09/893,109

LOW NOISE ROLLER CHAIN

APPELLANT'S BRIEF ON APPEAL

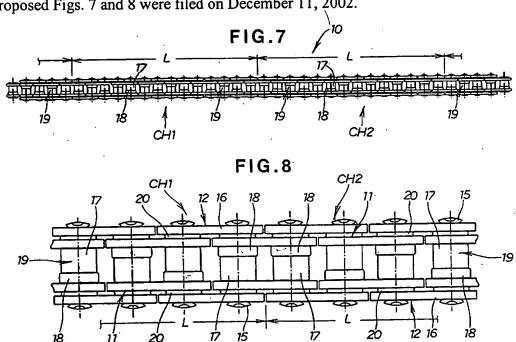
The original disclosure does not support the showing of two sections of chain, one beginning where the other ends, with elastic rollers in a zigzag configuration alternating

sides with each link, the zigzag configuration in each section 180 degrees out of phase with the adjacent section.

The Examiner disapproved them and indicated that they introduce new matter.

Applicant asserts that the drawings do not introduce new matter. On consideration of Fig. 1,

as well as the quoted portion of the specification above, it is clear that proposed Fig. 7 and 8 only show longer portions of the chain 10 of Fig. 1 except where two lengths "L" meet. It is at that point where the language of the specification describes what is shown in Figs. 7 and 8, namely, "the zigzag pattern of the elastic rollers 18 in one longitudinal chain portion is opposite in phase to the zigzag pattern of the elastic rollers 18 in the adjacent longitudinal chain portion."

It is requested that the proposed Figs. 7 and 8 be approved for entry in the case.

FIG.3

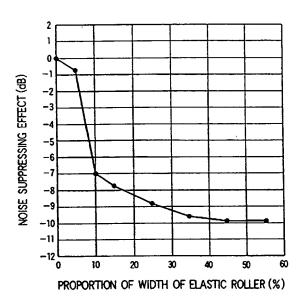
With reference to Fig. 3 shown below, the specification at page 8, lines 20-27 states:

Especially, with an increase in the proportion of the width of the elastic roller 18 from the (sic) 5 to 10%, the sound level sharply drops to about -7dB. . . . for a proportion of the width of the elastic roller 18, which is greater than 40% of the overall width of the roller assembly 19, no noise suppressing effect can be attained.

FIG.5

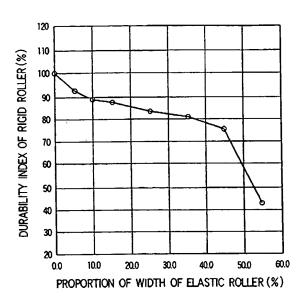
With reference to Fig. 5, shown below, the specification at page 10, lines 23 -24, states:

When the proportion of the elastic roller width exceeds 45%, the durability index drops abruptly.

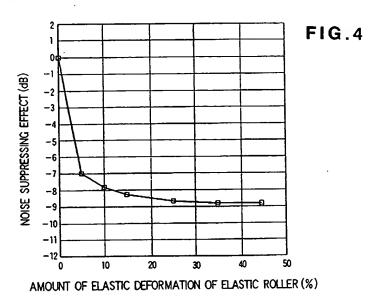
Likewise, with respect to the thickness range of the elastic roller, with reference to Fig. 4 and the specification at page 9, lines 15-22, experimental results establish an appropriate range of thickness which results in effective noise suppression, as follows:

As the amount of elastic deformation of the elastic roller increases from 0 to 5% of the thickness of the elastic roller 18, the sound level sharply drops to about -7dB. . . . For an elastic deformation of the elastic roller 18, which is greater than 20%, noise suppressing effect cannot be attained any more.

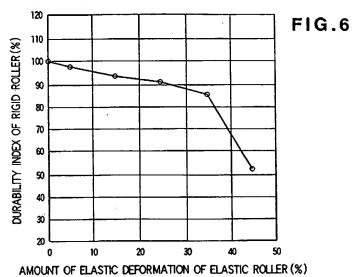
With reference to Fig. 6 and the specification at page 11, lines 17-19, it is stated:

When the amount of elastic roller deformation exceeds 35% of the thickness of the elastic roller 18, the durability index drops abruptly.
